Technical *Info*

Retrofitting of the V-ribbed belts on Renault 1.4 /1.6 16 V engines with K4J/ K4M air conditioning

Fig. 1
Type to be replaced

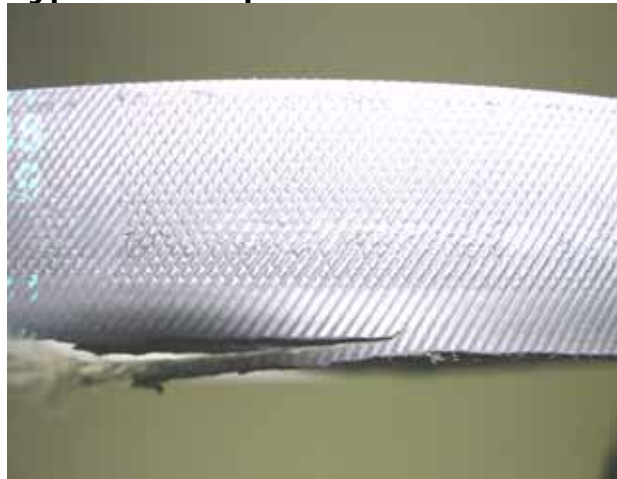
The belt is very noisy, wears quickly and exhibits signs of abrasion. Because of the sideways oscillation, the tensile member, including the ribs, might rip out of the belt. If a timing belt starts slipping as a result, this can, in turn, lead to serious engine damage.

The V-ribbed belt on older vehicles has six ribs (6 PK 1748).

The new belt has only five ribs (5 PK1750) to set the belt off from the engines more. According to Renault, this new belt should generally be installed.

The new 5-rib belt is placed only on the outer grooves of all belt pulleys; the inside groove remains free on all pulleys. In this connection, the generator's overrunning clutch should be checked to make sure that it is functioning perfectly and the hydraulic steering pump checked for axial clearance. (Misalignment!).

Before mounting the belt, remove any abrasion from the grooved pulley using a wire brush.
